**NOTICE
OSHTEMO CHARTER TOWNSHIP
ZONING BOARD OF APPEALS**

January 22nd, 2020

Request: Site plan approval for a 3,110 square foot building addition

Project Name: Ashley Homestore Addition

SITE PLAN
ASHLEY HOMESTORE
 PART OF THE SE 1/4 OF SECTION 13, OSHTEMO TOWNSHIP, KALAMAZOO COUNTY, MICHIGAN

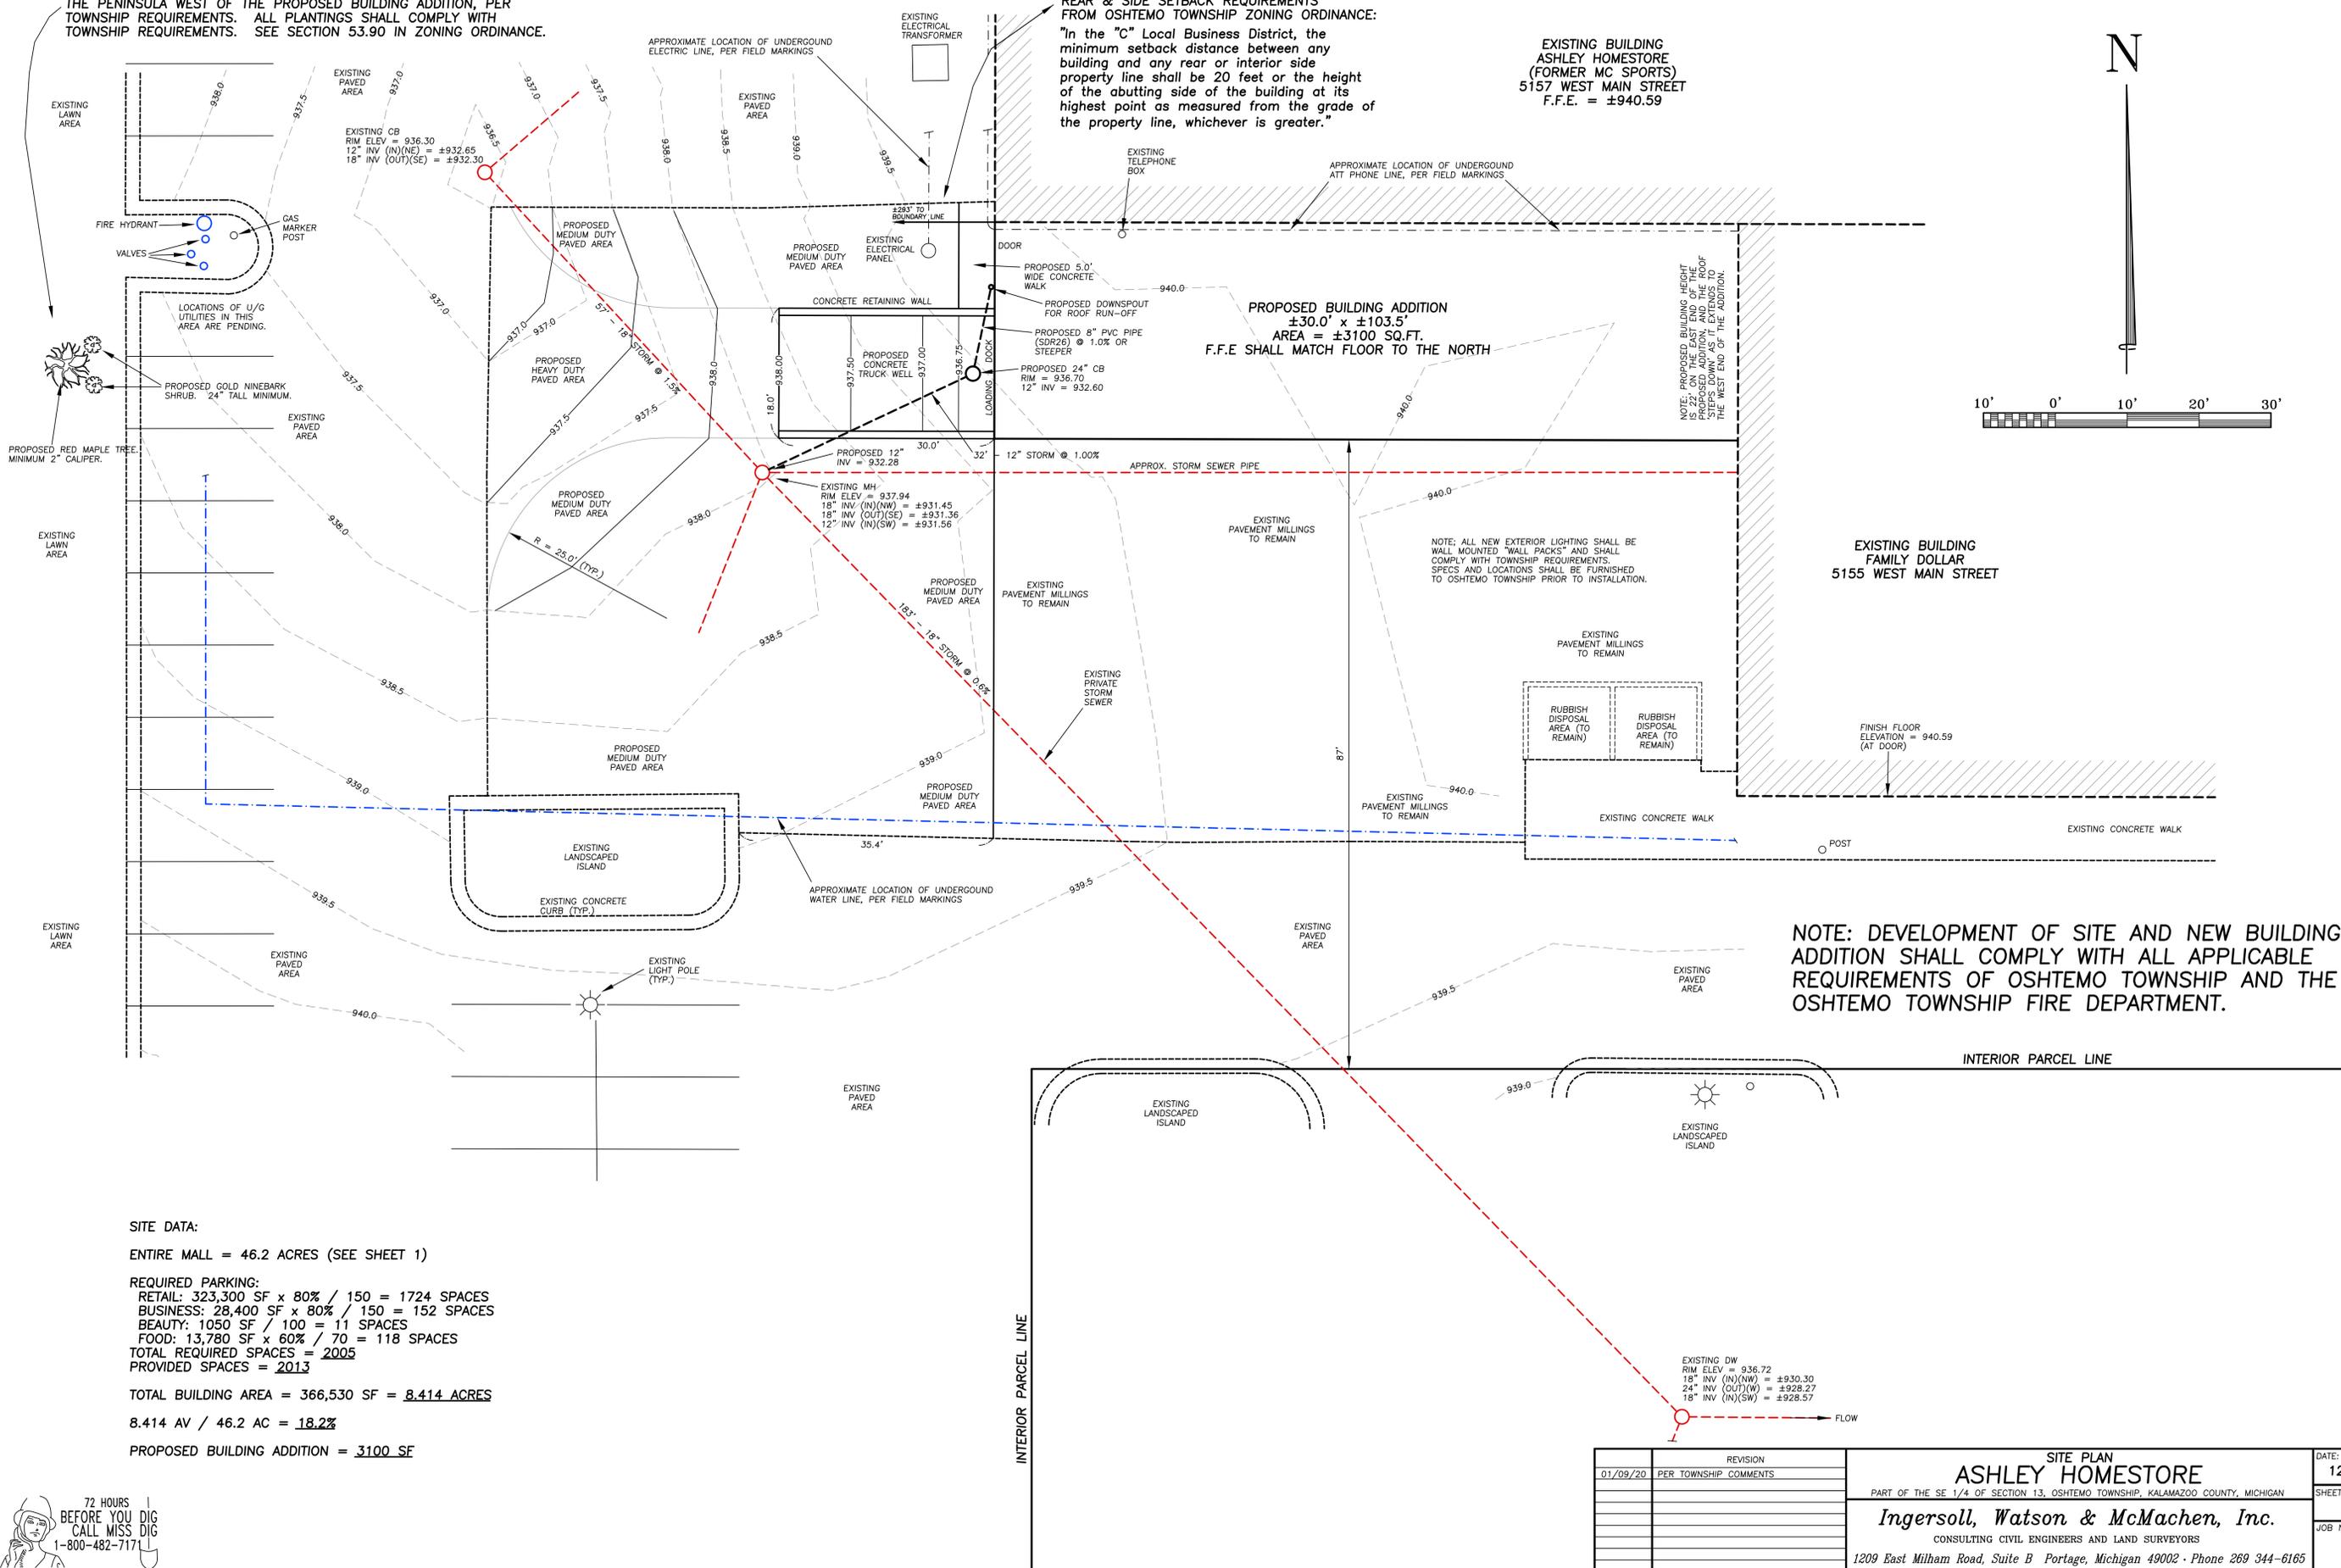
While no additional stormwater facilities are needed at this time, Township staff do have concerns that the proposed water inlet at the floor of the truck bay could allow some amount of petrochemicals, such motor oil and fuel that may drip from trucks, into the stormwater system. Township staff will continue to evaluate this concern as a part of this project and some kind of pre-treatment device or other means of pollution mitigation may be necessary.

1. Placement of the deciduous tree and two shrubs on the site plan shall be adjusted accordingly so that they are correctly located within the parking lot peninsula. This correction shall be

reflected on a revised site plan, submitted for administrative approval prior to issuance of a building permit.

2. If deemed necessary by Township staff, a stormwater pre-treatment device or other means of pollution mitigation shall be installed to ensure that additional pollutants do not enter the runoff network. Such shall be illustrated on a revised site plan, submitted to Township staff prior to issuance of a building permit.

NOTE: ONE DECIDUOUS TREE AND TWO SHRUBS SHALL BE PLANTED IN THE PENINSULA WEST OF THE PROPOSED BUILDING ADDITION, PER TOWNSHIP REQUIREMENTS. ALL PLANTINGS SHALL COMPLY WITH TOWNSHIP REQUIREMENTS. SEE SECTION 53.90 IN ZONING ORDINANCE.
